Tillegra Dam: socioeconomics

An independent review

NSW Department of Planning

October 2010

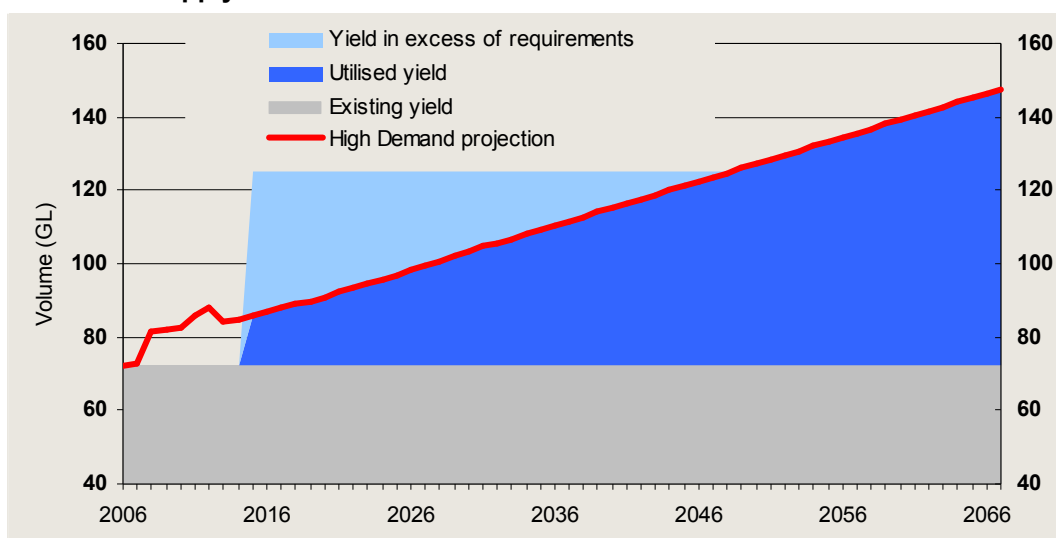
It is not clear why the CGE analysis has been structured in this way. In our view, the simulation should be about understanding the impact of increasing the supply of water (from the Dam) to meet the underlying demand for water. This would be a more realistic approach given that Hunter Water's demand projections have already incorporated assumptions regarding the increases in economic activity in the region. Further, given that the economic activity in the region is currently not constrained by water scarcity (and is not likely to be constrained for some time) the assumption that an additional 72 GL of water is required to meet demand from 2015 onwards would appear unrealistic. This is particularly true given that water prices are currently regulated by the Independent Pricing and Regulatory Tribunal of NSW (IPART) and do not reflect the scarcity of water. For example, in periods of low water availability, prices do not rise to reflect the scarcity value of water which would be expected if the price of water was not regulated.

Further, the EAR also recognises that the construction of the Dam will result in significant excess capacity for the next 30 years. The following chart, which is reproduced from the Working Paper G highlights this point.
